## **Access Compliance Report Public Rights-of-Way** (Curb Ramps)

Intersection ID: 29231 Main Street: KORNIV DR **Cross Street: COPPALA DR** Location: NW ADA ID: C1B7388D051C Ramp Type: PerpDiag Initial Pass/Fail: Pass **Overall Compliance: No Severity Score:** 27.5

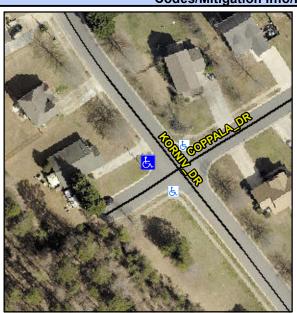
**COPPALA DR** Street 1 Name Stop Condition-Street 2 None Street 2 Name **KORNIV DR** Stop Condition-Street 1 None Possible Solutions: **Remove & Replace Curb Ramp With** Two New Directional Ramps or Equivalent. Surveyor Notes: N/A PROW/ADA: Not Found, R304.2.1, R304.2.2-Perp, R304.3.2-Para, R304.5.3, R305.1.4, R305.2, R302.7.2
